Hidden Hills Solar Electric Generating System (HHSEGS)

(11-AFC-2)

**Data Response, Set 1C
(Response to Data Requests 77 though 96)**

Submitted to the
California Energy Commission

FIGURE DR77-1
Private Land Ownership
Hidden Hills Solar Electric Generating System

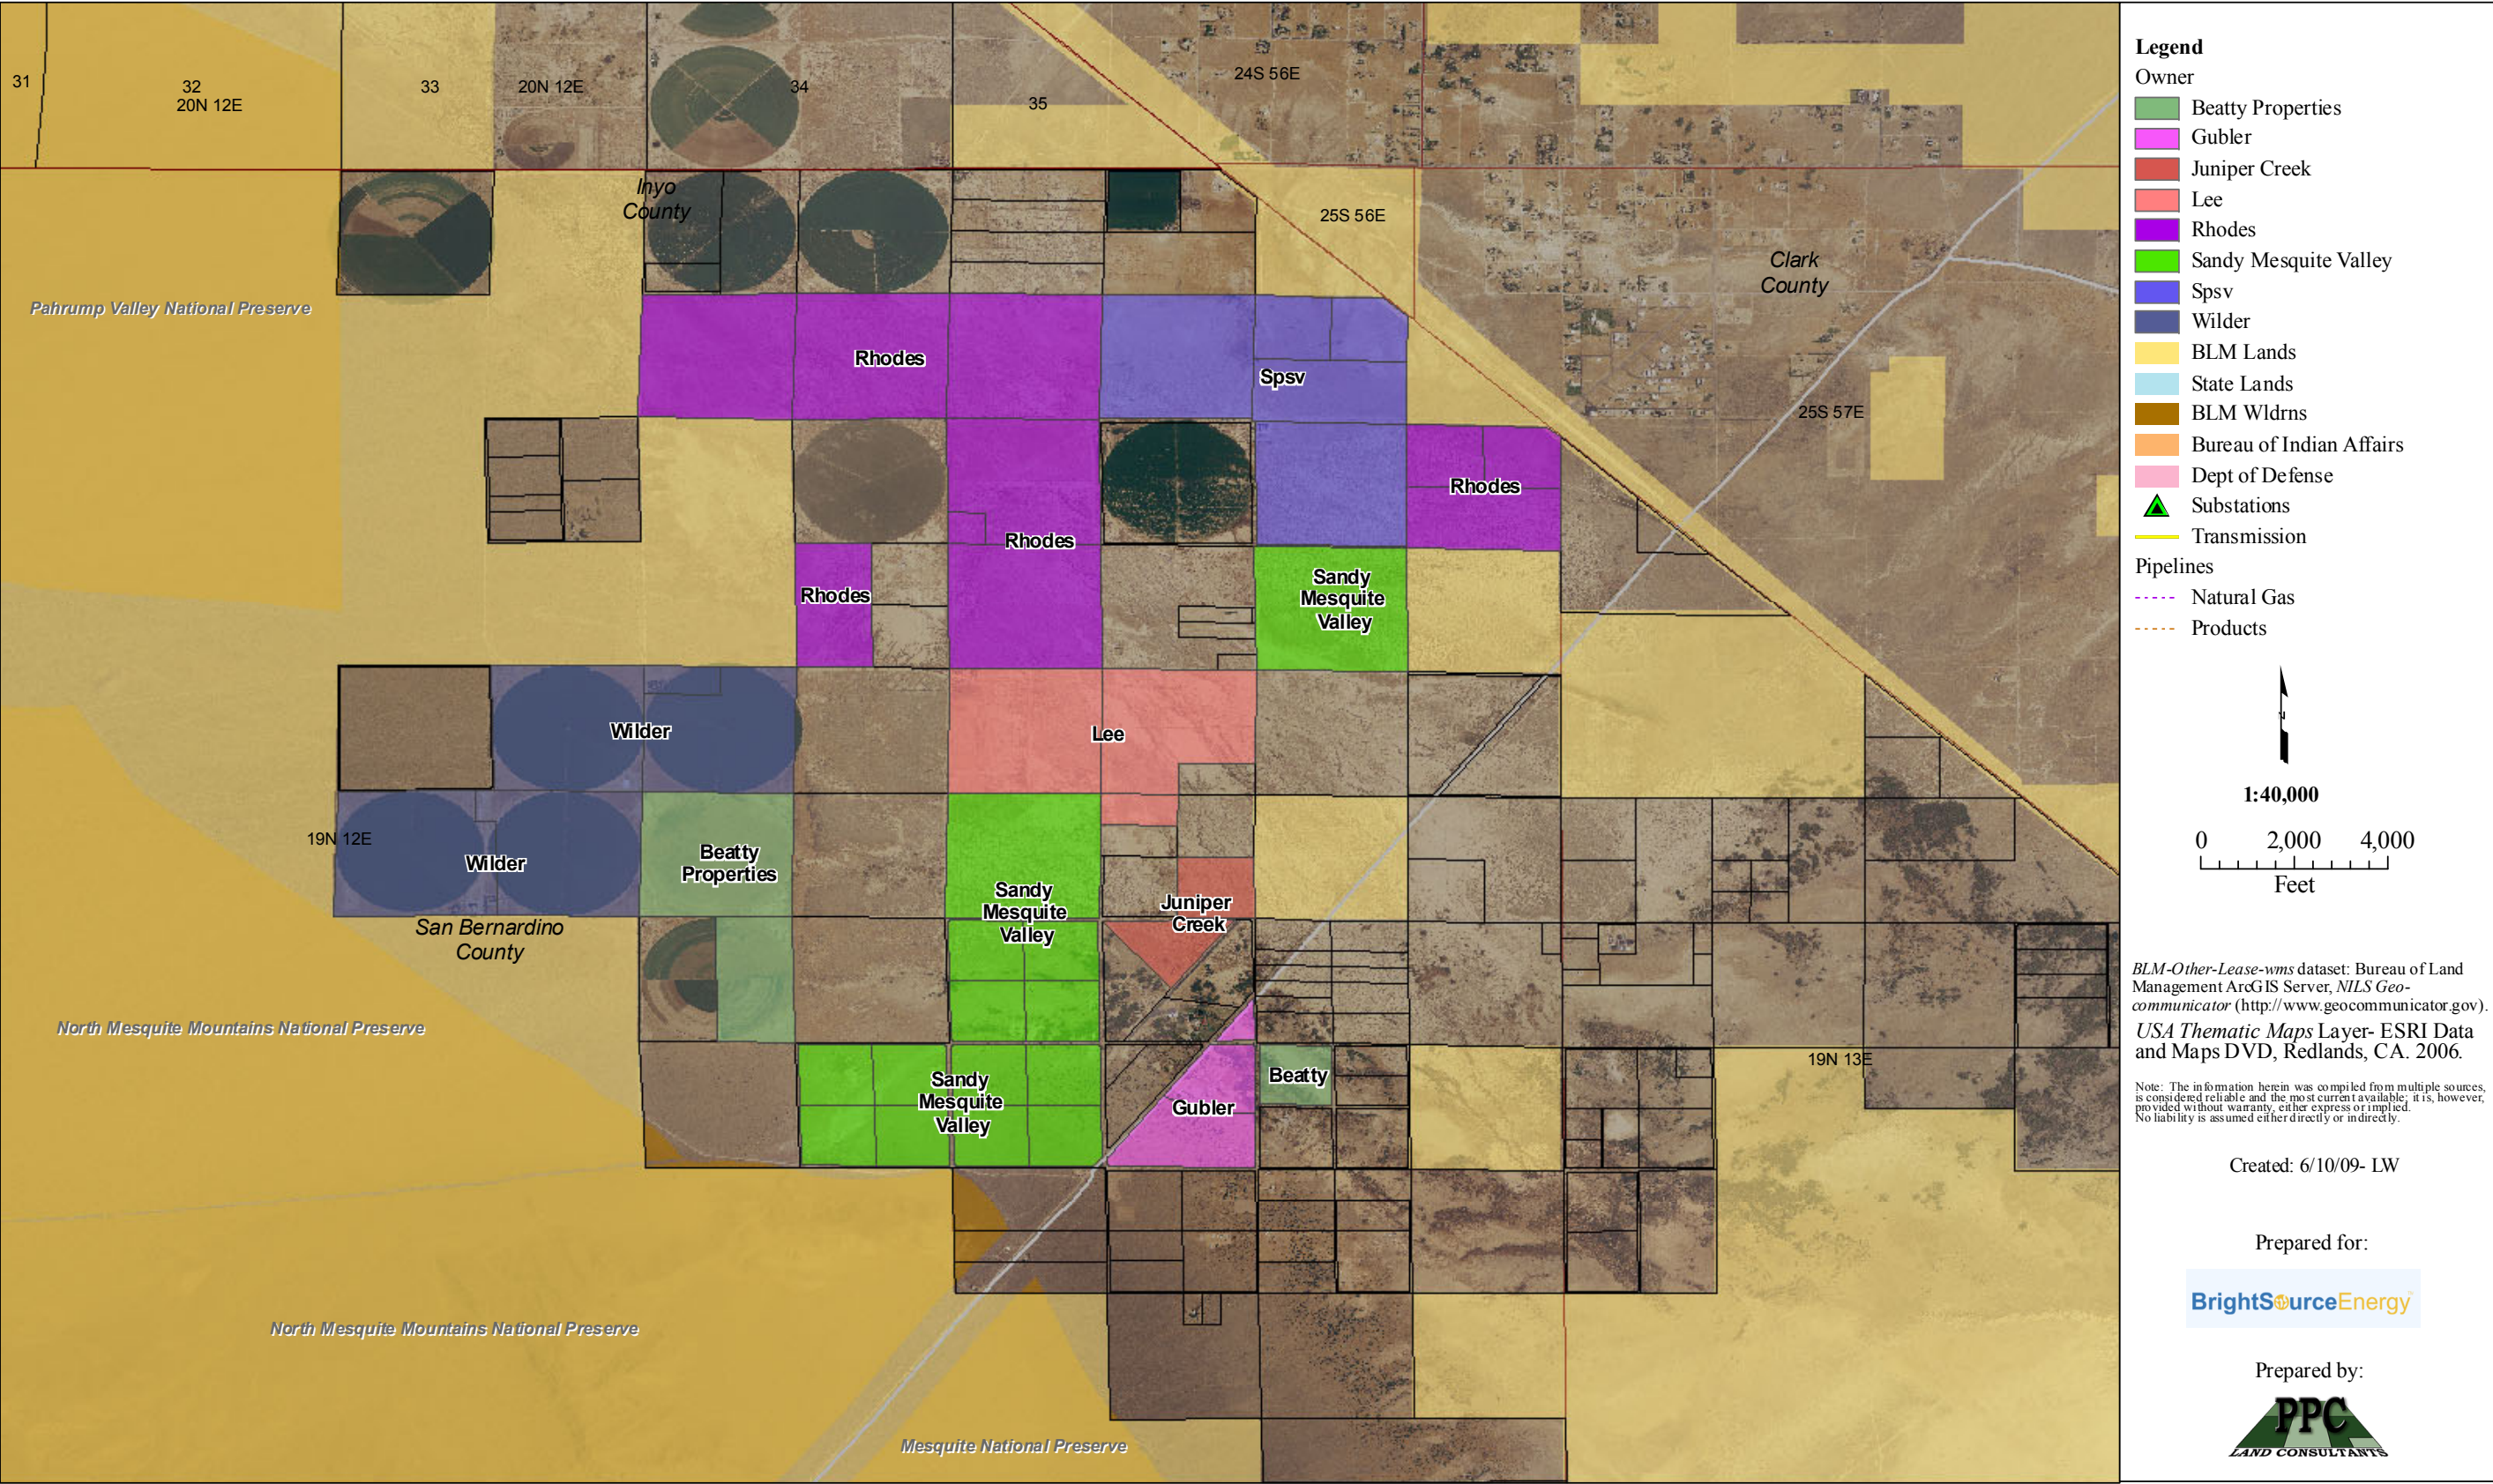
- a. Information on slope and potential available acreage in the area, including potentially available contiguous acreage in the northeast corner of San Bernardino County. Include a map showing a possible project site and footprint. Describe the topography and elevations in the area.

- b. Information on the number of landowners with property in the area. Discuss land ownership for the area and the acreage of land that is privately owned.

Response: The Sandy Valley area was eliminated from further analysis primarily as a result of the number of private property owners (see Figure DR77-1) and private parcels that make it very difficult (if not impossible) for an entity without the power of eminent domain to assemble parcels of sufficient size and shape to make the project work.

Response: Land ownership information is depicted on Figure DR77-1.

FIGURE DR82-1 MAP SHOWING SITE DRAWDOWN CONTOURS RELATIVE TO AMARGOSA RIVER AREA OF CRITICAL ENVIRONMENTAL CONCERN (ACEC), MAXIMUM DRAWDOWN SCENARIO AT 140 ACRE-FEET/YEAR.

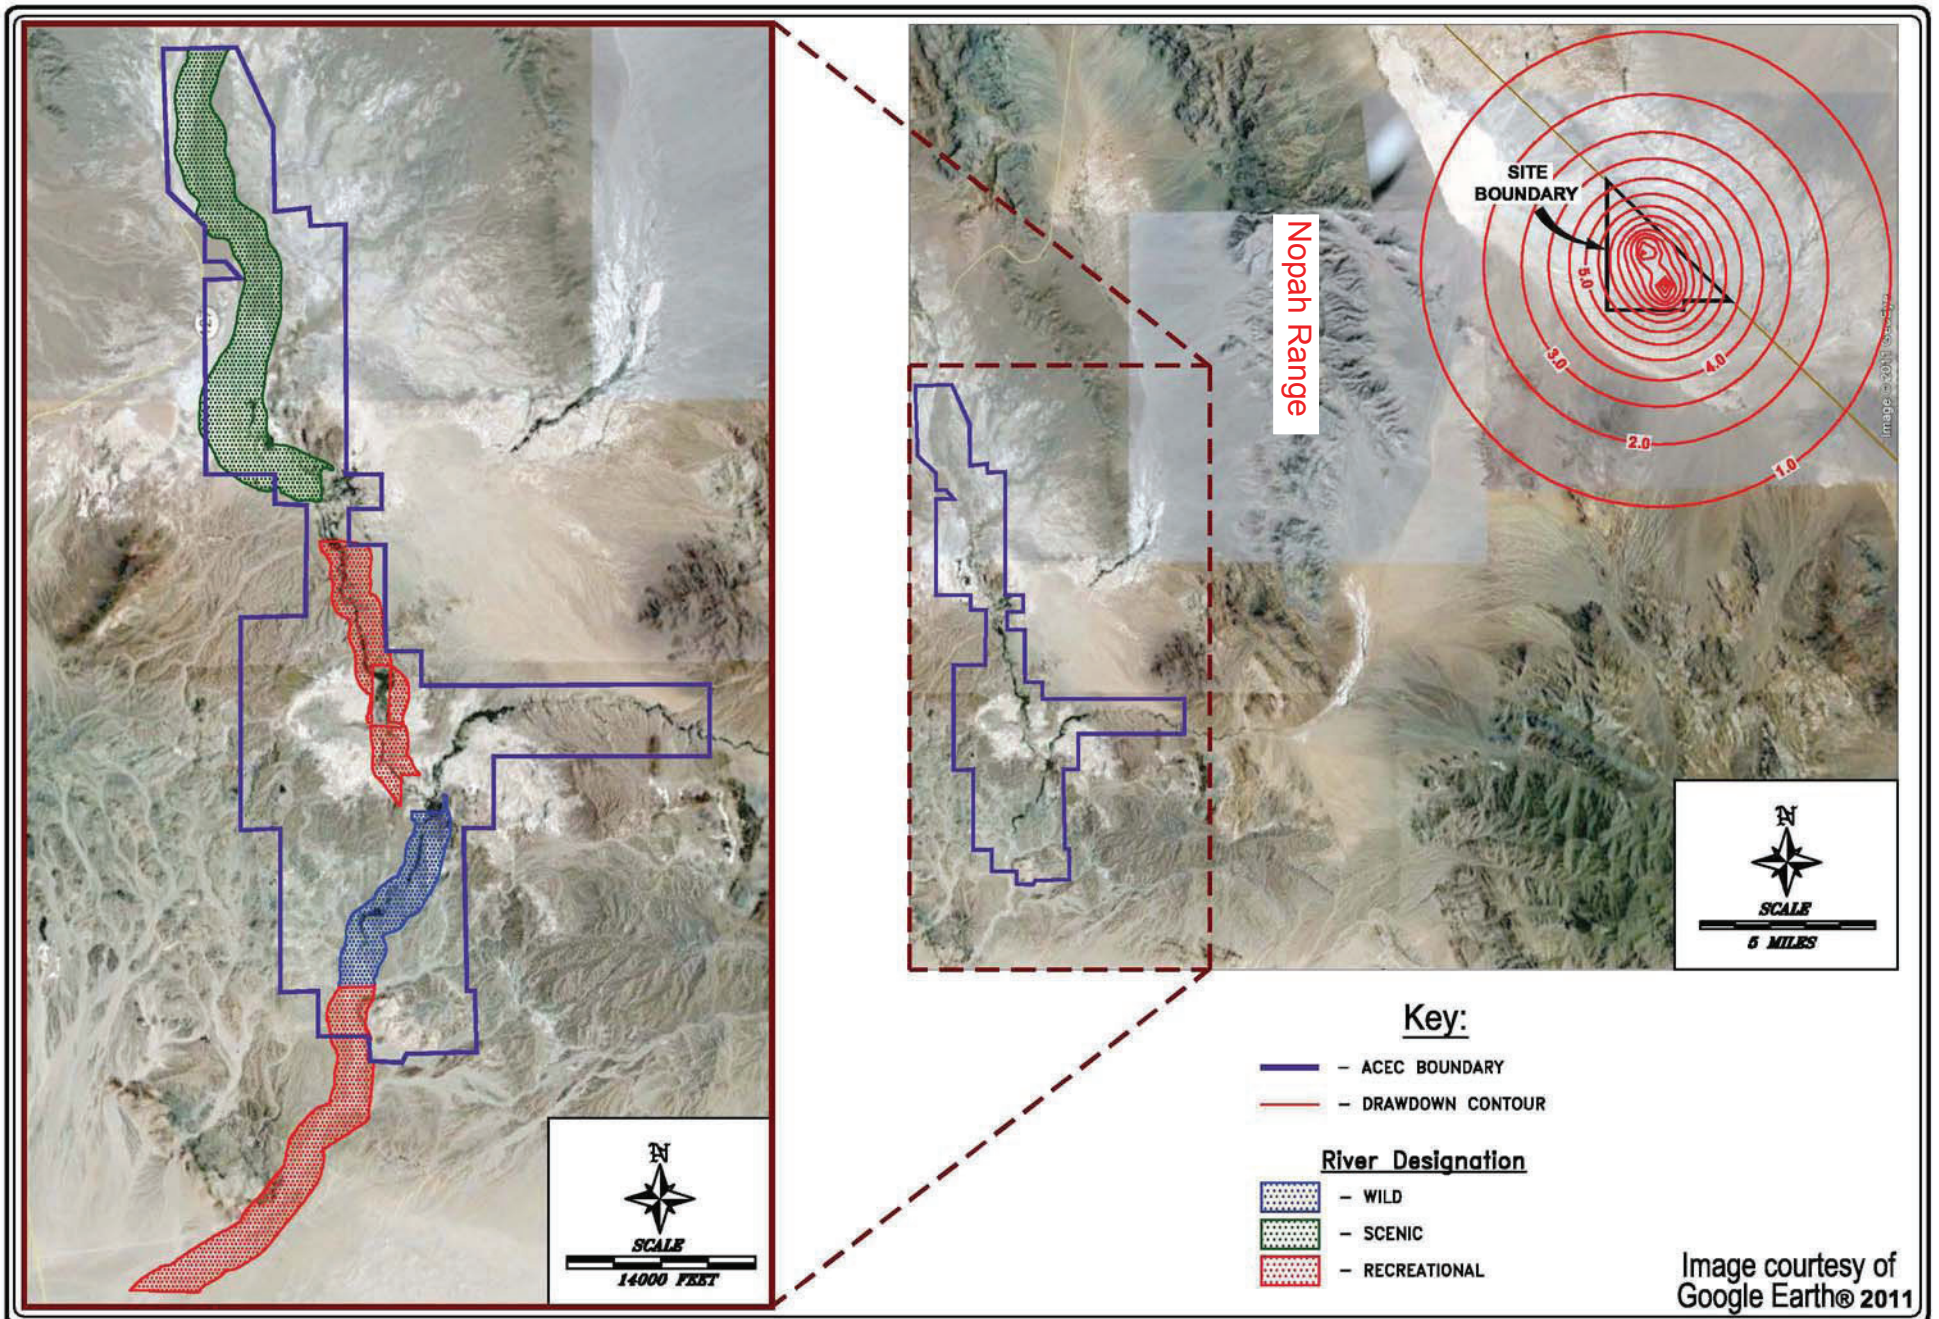
82. Please provide a map (no greater than 1:25,000) depicting the cone of depression of drawdown including predicted groundwater drawdown relative to the Amargosa River, Amargosa Wild and Scenic River (WSR), and the Amargosa River Area of Critical Environmental Concern (ACEC). Also, please provide an analysis which evaluates the potential for this drawdown to affect the Amargosa ACEC/WSR. This

Response: Figure DR82-1 is a map illustrating the modeled extent of drawdown in the basin fill aquifer in response to the most conservative alternative for project pumping as provided in Scenario 2, Appendix 5.15G, Groundwater Modeling Technical Memorandum, July 20, 2011 (CardnoENTRIX 2011). In this scenario, the distance between the one-foot drawdown contour and the closest reach of the Amargosa River is approximately 12 miles. Therefore, even if the basin-fill aquifer extended all the way to the Amargosa River (which it cannot due to intervening structural discontinuities discussed below), there would not be a measurable drawdown at the Amargosa River as a result of the project's groundwater pumping. Therefore, because the basin fill aquifer is not laterally-continuous between the project site and the Amargosa River and the predicted drawdown would not extend that far even under the most conservative of the selected modeling alternatives, project pumping will not affect the Amargosa River.
